Transport for NSW

Proposed upgrade of Hill Road at Sydney Olympic Park and Lidcombe

Community Consultation Report

Hill Road and John Ian Wing Parade

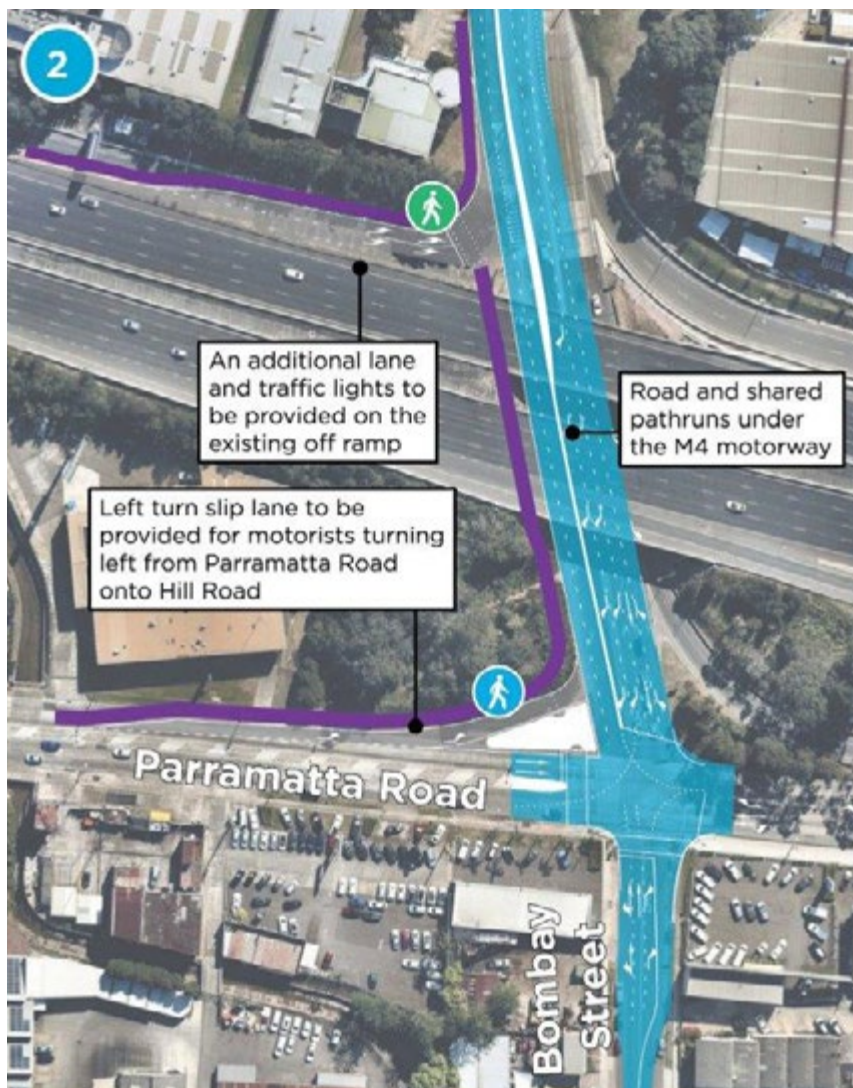
"I would like to know why the left hand turn lane out of John Ian Wing Parade onto Hill Road has been left off. As a Newington resident I am hoping this is just an oversight as this is well used by Newington residents to access Sydney Olympic Park, Wentworth Point, Rhodes, Concord and Ryde."

"Could you please explain why the existing left turn from Wing Parade onto Hill Road seems to have been left off the upgrade?"

"What will happen to the bus routes 525 and 526 that turn left at Hill Rd at the intersection with John Ian Wing Parade, since there will be no left turn arrows at that intersection coming from Newington? Also why can't you be able to go straight ahead into Carter St precinct from John Ian Wing Parade?"

"Why is there no slip lane from Hill Road to John Ian Wing Parade, and from John Ian Wing Parade onto Hill Road? I could see that lots of cars still need to turn into Newington or bypass Parramatta Road to Silverwater."

Left turns and through movements at the intersection of Hill Road and John Ian Wing Parade will continue to be permitted after the upgrade is completed.

The diagram included in the December 2020 Community Notification showed physical line markings and direction arrows as they will appear on the roadway after the proposed upgrades are completed. A number of respondents raised concerns the absence of arrows in other directions meant some existing movements would no longer be permitted. This is not the case and TfNSW apologises for the misunderstanding.

This report includes a new drawing of the roadway at Appendix A, which shows the physical road markings as they will appear on the road at the completion of the upgrade, as well as arrows indicating through movements or other turns.

Proposed Hill Road upgrade

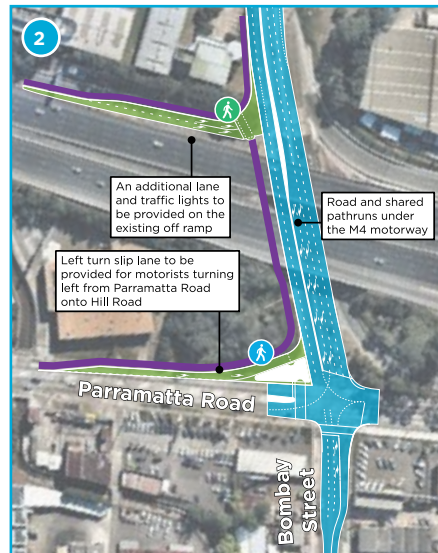
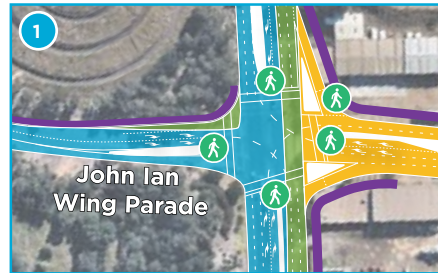
"[The proposal diagram indicates a] median going north along Hill Road from Parramatta Road to John Ian Wing Parade. However, unless this is a substantial physical barrier ... it will not prevent drivers ... trying to move to right-hand lane to turn right into Carter Street ... making illegal U-turns onto M4 eastbound on ramp."

As part of the proposed upgrade, TfNSW will prohibit right turns into and out of Carter Street from Hill Road (left-in and left-out turns will be permitted). In addition, a continuous raised median will be constructed along Hill Road between Parramatta Road and John Ian Wing Parade. This will present a physical barrier to illegal turns, including shortcut access to the M4 east and westbound on ramps.
